RIGOH	Technical B	ulletin	No.	IFO-001
SUBJECT: Dial Tone Detection	on in the Netherland	ls		<b>DATE:</b> Feb. 29, 1996
PREPARED BY: K. Ugaeri CHECKED BY: M. Iwasa		FROM: Qua	ality Ass	urance Center
CLASSIFICATION:  Action Required Troubleshooting Retrofit Information	Revision of servi Information only Other	ce manual	MODE IF	
<b>NL</b> only

SUBJECT: Gear 3 of Paper Tray Came out			<b>DATE:</b> MAR.15.1996
PREPARED BY: K,Ugaeri CHECKED BY: M. Iwasa	FROM: QA	Center	
CLASSIFICATION:		MODE	L:
<ul><li>■ Action Required</li><li>□ Troubleshooting</li><li>□ Retrofit Information</li><li>□ Other</li></ul>		IF	0

KUGUU	Technical B	Bulletin	No.	IFO - 004	
SUBJECT: New Service Par	ts			DATE: 1996	
PREPARED BY: K.Ugaeri CHECKED BY: S.Fujii		FROM: Qu	ality Ass	urance Center	
CLASSIFICATION: Action Required Troubleshooting	Revision of servi		MODE	L: IFO	
□ Retrofit Information	□ Other

RIGOH	Technical E	Bulletin	No.	IFO - 006
SUBJECT: Gear 3 of Paper	Tray (2)			DATE: Sep. 15, 1996
PREPARED BY: K.Ugaeri CHECKED BY: S.Fujii		FROM: Qu	ality Ass	urance Center
CLASSIFICATION:			MODE	L:
Action Required	Revision of servi	ce manual	IF	0
Troubleshooting	Information only			
Retrofit Information	Other

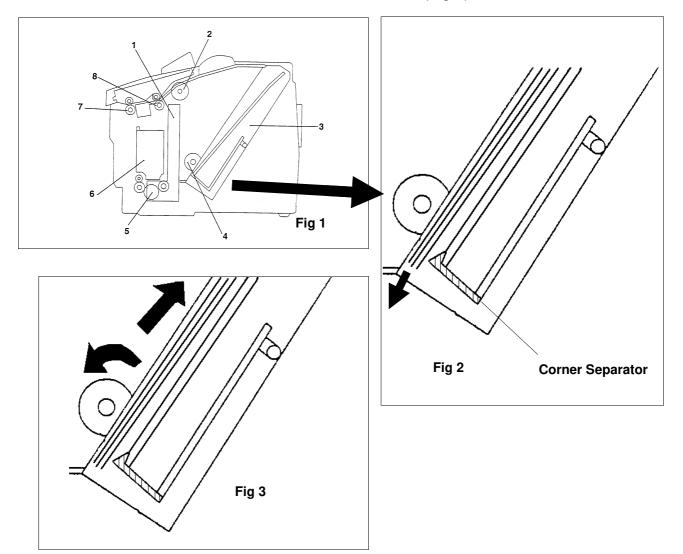
Symptom: Paper non-feed

Cause: This is caused by operator mistakes.

If the paper is added in the paper tray without pulling up

the release lever, the paper will be set over the corner separator.

This causes the paper to be multifed and jammed. (Fig 2)

If the operator removes the jammed paper from the paper tray without pulling up the release lever, the feed roller will be turned in the reverse

direction and Gear3 and/or Gear2 will come out. (Fig 3)

#### Temporary countermeasure:

The caution decal will be added beside the release lever. (refer to Fig 4.)

#### 1.OP - PORT COVER

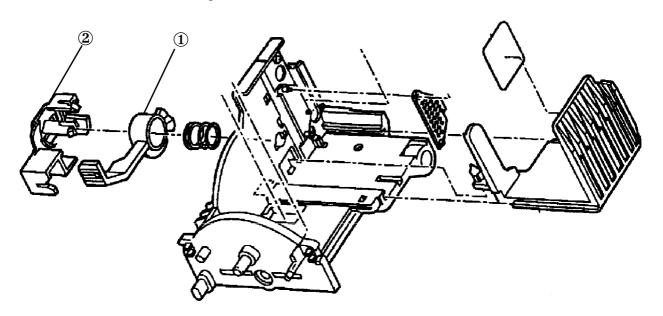
① H505 4231 Cover - OP Port (For Ricoh, NRG and Infotec models)

2 H505 4230 Cover - OP Port (For Danka models)

\* When the operator opens the ADF from the rear side, the hook of the operation panel cover may be broken.

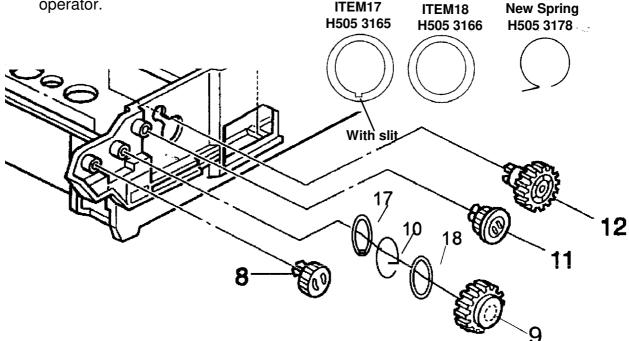
Sympton: Paper non - feed. (Unable to Use Printer Display)

Cause: When the feed roller turns in reverse, a spring holds the shaft and presses against Gear2, then Gear3 and/or Gear2 are removed because of too much spring torque.

Permanent Countermeasure: A spiring has been changed and 2 collars have been added to Gear2. The new spring has less torque than the old one. New, Gear2 turns free even if the feed roller turns in reverse.

This countermeasure will be available from September 1996 production.

Action: When the machine has this problem, replace the spring and add the 2 collars.

If the machine does not have a a caution decal, place it and explain the caution to the operator.

**Checking Procedure**

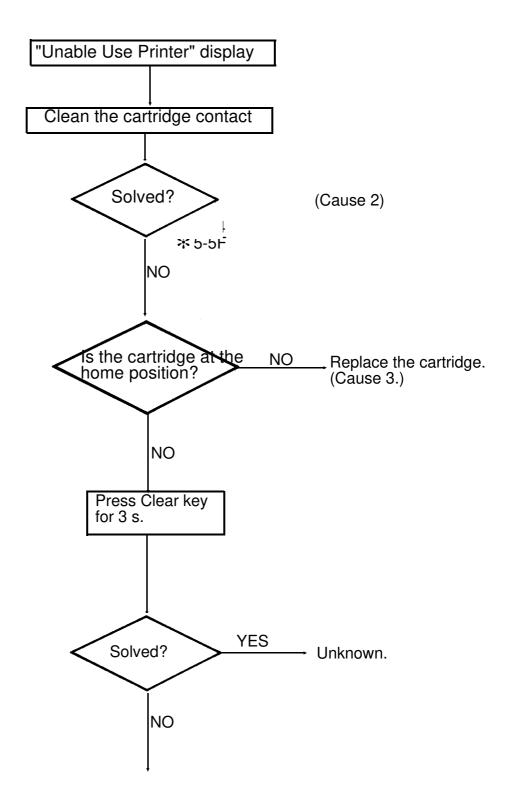
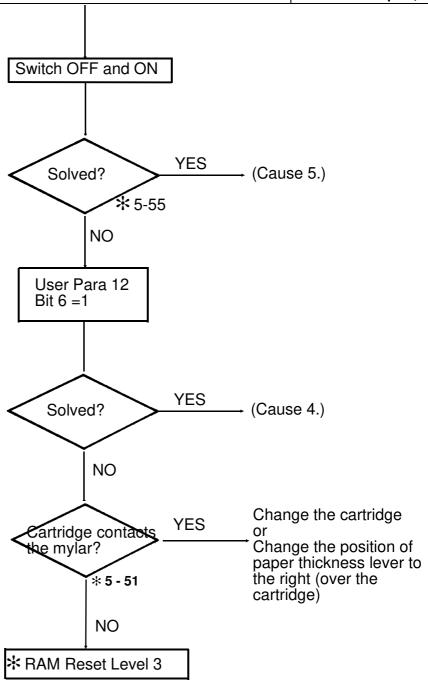
cause 5: Ram check error when initializing. (Error code5-55)

<Action> : Switch off and on.

- ★ Do not use RAM Reset before the previous procedure.
- ★ If the problem cannot be solved by the above action, dispatch a technician to the customer.

#### **CAUSE**

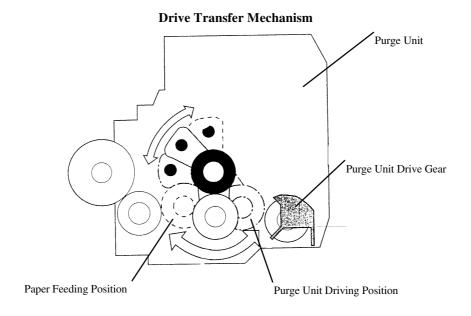
A blank page is fed out just before the start of printing.

This is especially likely to occur in the first printing run after a long time on standby (e.g. first print in the morning).

Ink is unexpectedly stuck to the drive transfer gear.

Impure ink is not absorbed into the absorber sheet and remains on the surface.

The absorber became full and the ink ended up sticking on the gear.

- 1.Replace the Ink absorber sheet and Ink absorbers (Do not forget to initialize the TIJ counter)
- 2.Clean the drive transfer gear.
- 3.Instruct the customer not to use impure ink.
